Report: TAB REPORT
Function: Test, Adjust, & Balance
Date: 06/26/2023

PROJECT
06-19-23 CULVERS - COLUMBUS, GA

Project: 06-19-23 CULVERS - COLUMBUS, GA

Issue List

HVAC DUCT PLAN

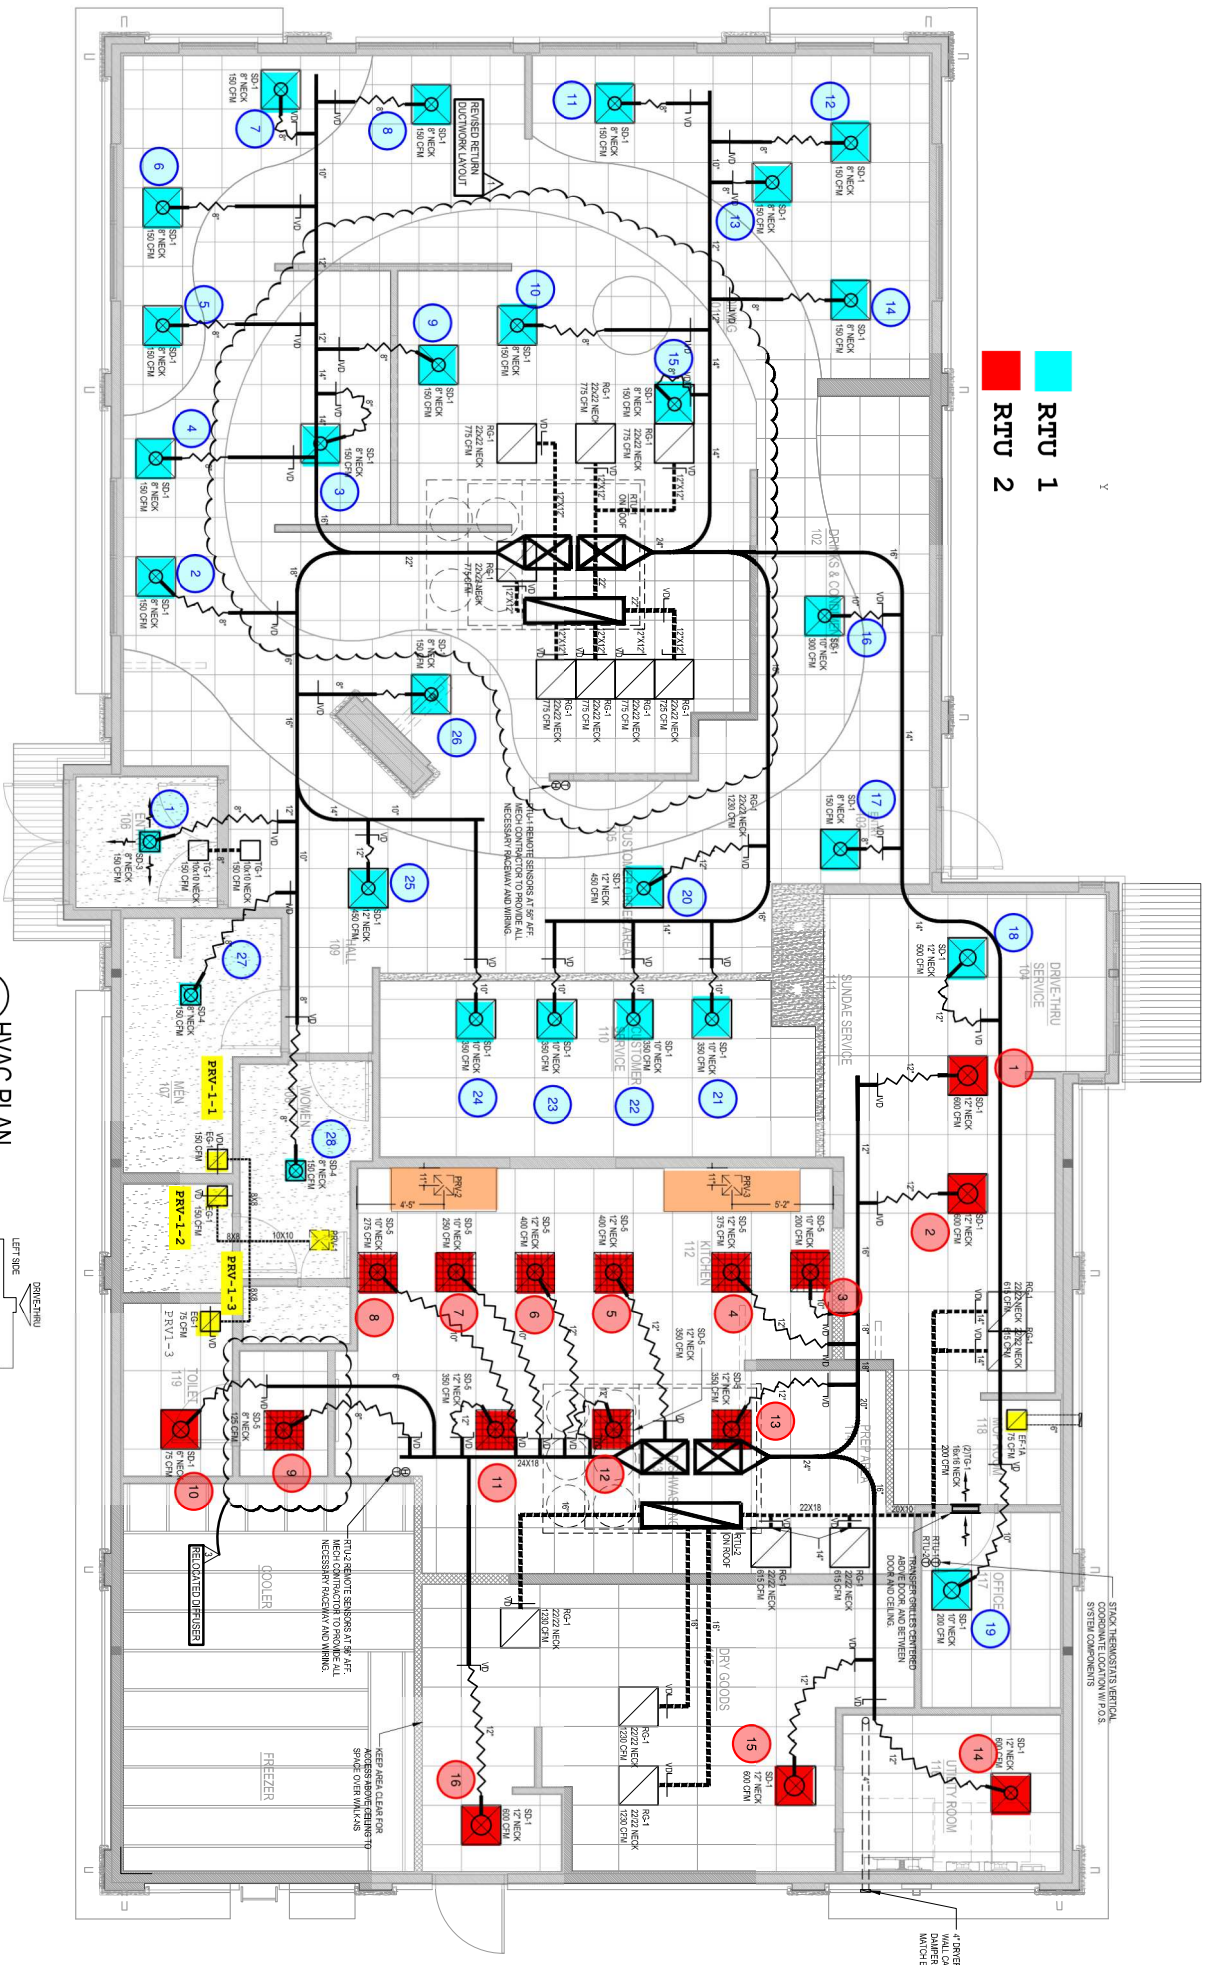
Issue Name : HOOD CAPTURE
Description : WITH HOOD AT DESIGN FLOW AND LINE DIFFUSERS IN DESIGN AIRFLOW CAUSES HOODS TO FAIL TO FULLY CAPTURE. TECHNICIAN VERIFIED WITH KITCHEN UNITS OFF AND REAR DOOR OPEN THE HOODS CAPTURED CORRECTLY. DUCTWORK NOT INSTALLED PER DESIGN. SEE MSET PAGE M201 DETAIL C6. DIFFUSERS ARE MISSING RIGID 90 AND 12" RIGID DUCT RUN. RETURN STYLE DIFFUSERS ARE INSTALLED INSTEAD OF SUPPLY. RECOMMEND MECHANICAL CONTRACTOR INSTALLS DUCT PER DESIGN.

Issue Name : INCORRECT DAMPERS INSTALLED
Description : MSET CALLS FOR VOLUME DAMPERS AT SUPPLY TAKEOFFS, INSTEAD DAMPERS WERE INSTALLED AT FACES OF DIFFUSERS. SEE MSET M201 DETAIL C6. EXISTENCE OF BRANCH DAMPERS COULD NOT BE VERIFIED DUE TO SPRAY FOAM INSULATION ON DUCT. THE FACE DAMPERS CAUSE EXCESSIVE NOISE AT SEVERAL DIFFUSERS.
Created By : National TAB **Assigned To :** National TAB - William Patton
Status : Open
Originated Date : 06/21/2023 - William Patton - National TAB

Issue Name : OFFICE DIFFUSER DUCTWORK
Description : OFFICE SUPPLY DIFFUSER IS DUCTED TO RTU2 INSTEAD OF RTU1. MSET M101 CALLS FOR THAT DIFFUSER TO BE DUCTED TO TO RTU1. PER MECHANICAL THE TRUSS WORK MAKES DUCTING TO RTU1 IMPOSSIBLE. THIS MAY LEAD TO UNCOMFORTABLE TEMPERATURES IN OFFICE AS THE KITCHEN CALLS HAS A DEMAND FOR COOLING WIEN THE OFFICE IS ALREADY COLD.
Created By : National TAB **Assigned To :** National TAB - William Patton
Status : Open
Originated Date : 06/21/2023 - William Patton - National TAB

Issue Name : RTU 1 LOW DIFFUSERS
Description : AS A RESULT OF INCORRECT DAMPERS BEING INSTALLED AND THE DUCTWORK LAYOUT DIFFERING FROM THAT SHOWN ON THE MSET THERE ARE 4 DIFFUSERS THAT ARE BELOW DESIGN. SEVERAL FULL PASSES WERE MADE TO ATTEMPT TO RESOLVE THIS BUT WERE UNSUCCESSFUL. SPACE IS COMFORTABLE AS IS.
Created By : National TAB **Assigned To :** National TAB - William Patton
Status : Open
Originated Date : 06/21/2023 - William Patton - National TAB

Issue Name : RTU 2 DIFFUSER 15 LOW FLOW
Description : DIFFUSER 15 (DRY GOODS) IS 351 CFM. DESIGN IS 600CFM. AFTER SEVERAL FULL PASSES TOTAL INCREASE IN FLOW TO THIS DIFFUSER WAS 63 CFM, WITH ALL OTHER DIFFUSERS FALLING WITHIN DESIGN. AFTER INSPECTION TECHNICIAN COULD NOT DIAGNOSE WHAT IS CAUSING RESTRICTION. RECOMMEND MECHANICAL CONTRACTOR INVESTIGATES DUCTWORK AND VOLUME DAMPER FOR ANY ISSUES.

- **06/22/2023 National TAB - William Patton**
 - RECOMMENDED TO INSTALL VOLUME DAMPERS FOR THE DIFFUSERS AT THE TAKEOFFS. IT IS ALSO RECOMMENDED TO INSTALL BRANCH DAMPERS. NTAB WAS UNABLE TO SEE OR USE ANY BRANCH DAMPERS DUE TO SPRAY INSULATION ON THE DUCTWORK.
